Technical Service Bulletin: TSB160095

New Exhaust Gas Temperature Sensor and Injector Quadrant Wiring Harness and Mounting Bracket

Figure 1, New Exhaust Gas Temperature Sensor and Injector Wiring Harness with Mounting Brackets.

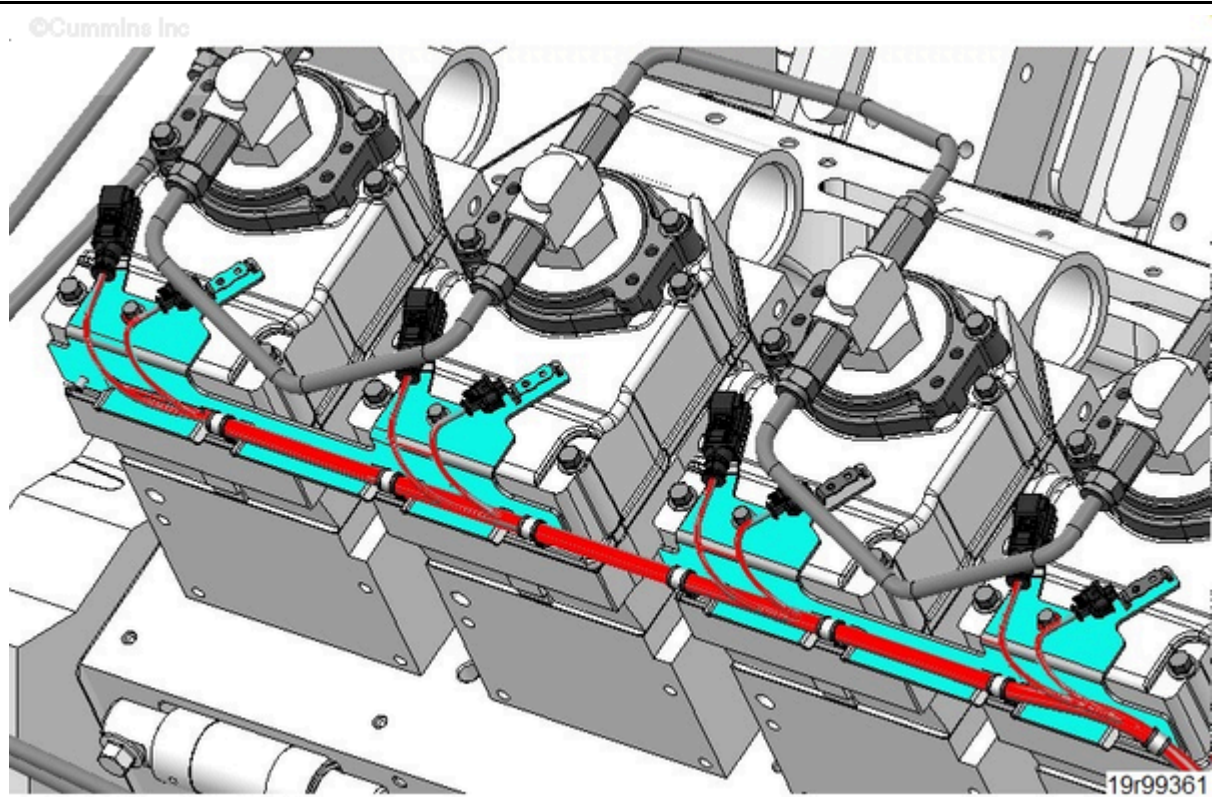
The new wiring harness incorporates a mounting bracket that spans two cylinder heads. Each wiring harness consists of two mounting brackets in total, covering four cylinder heads. See Figure 1 below.

- A new engine wiring harness and bracket assembly including the new exhaust gas temperature sensor and injector wiring harness, and new cylinder head mounting bracket has been released.

- The new components reduce the likelihood of the wiring harness connectors coming loose during operation and reroute the wiring harness to prevent wiring harness fretting caused by incorrect contact with the cylinder block, cylinder head, camshaft cover, or aftercooler housing.
